MINERALS PROGRAM INSPECTION REPORT
PHONE: (303) 866-3567

MINE NAME: Cresson Project	MINE/PROSPECTING ID#: M-1980-244	MINERAL: Gold	COUNTY: Teller
INSPECTION TYPE: Monitoring	INSPECTOR(S): Timothy Cazier	INSP. DATE: July 29, 2020	INSP. TIME: 09:00
OPERATOR: Cripple Creek & Victor Gold Mining Company	OPERATOR REPRESENTATIVE: Katie Blake, Jeana Ratcliff	TYPE OF OPERATION: 112d-3 - Designated Mining Operation	
REASON FOR INSPECTION: Normal I&E Program	BOND CALCULATION TYPE: None	BOND AMOUNT: \$209,491,188.00	
DATE OF COMPLAINT: NA	POST INSP. CONTACTS: None	JOINT INSP. AGENCY: None	
WEATHER: Clear	INSPECTOR'S SIGNATURE: 	SIGNATURE DATE: September 3, 2020

Photo 18. Hole on east side of Altman backfill enclosed in dotted line, groin erosion denoted by dashed arrow.

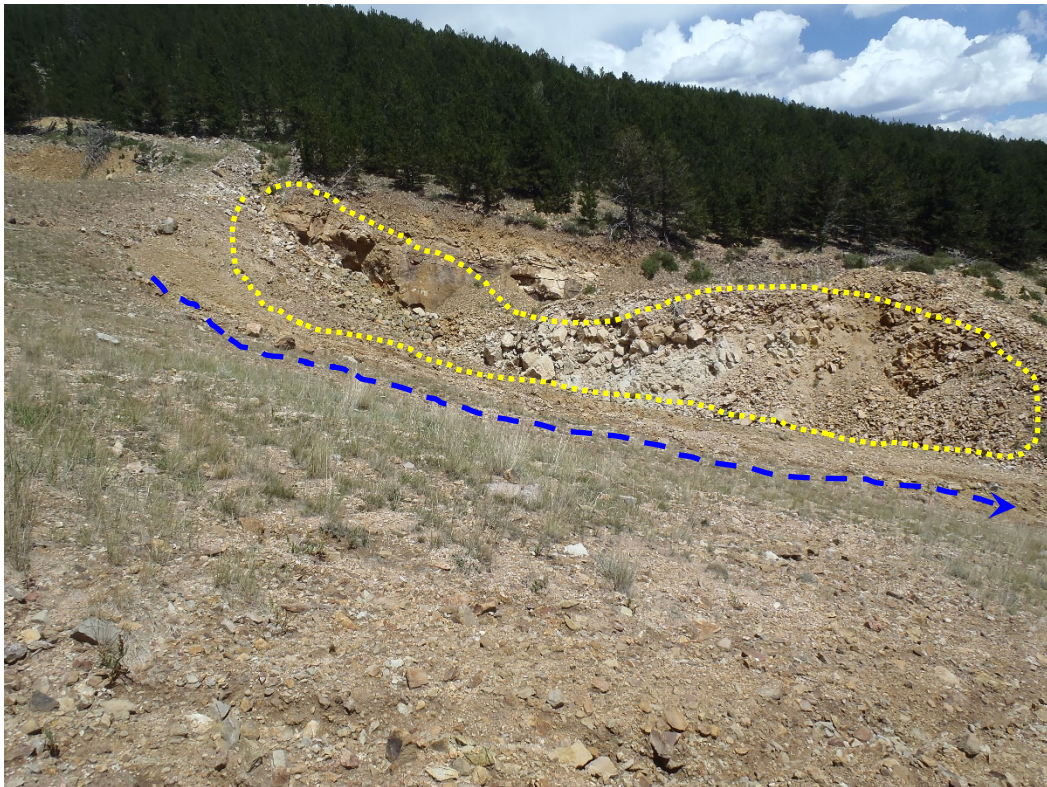
Altman Backfill erosion: The erosion features identified from our May aerial inspection (reference May 18, 2020 inspection report Photo 13A) were investigated. The attached **Figure 1** shows the area in detail. The alluvial fan deposit at the base of the largest erosion gully was measured to be 29 feet at its widest (see **Photo 13**) and 73 feet long (see **Photo 14**). Three primary gullies appeared to be the contributors to the fan deposit (see **Photo 15**). The gullies ranged in size from 28 to 52 inches wide and 14 inches to 38 inches deep (see **Photo 16**). Groin erosion along the contact between the backfill and native ground was also observed (see **Photo 17**). *If stormwater is to continue along this groin alignment for final reclamation, erosion protection armoring will be required.* A hole (see **Photo 18**) which did not get backfilled as part of the Altman reclamation effort is in close proximity of the observed groin erosion. As no apparent offsite impact was observed, the DRMS is not citing a problem for these conditions. *However, CC&V needs to be aware the DRMS cannot approve reclamation release under these conditions as they do not meet the requirements of Rules: 3.1.5(3) – “All grading shall be done in a manner to control erosion and siltation of the affected lands, to protect areas outside the affected land from slides and other damage.”; and 3.1.6(3) – “All surface areas of the affected land, including spoil piles, shall be stabilized and protected so as to effectively control erosion.”.* It should also be noted the observed hole is not allowed under the approved reclamation plan.
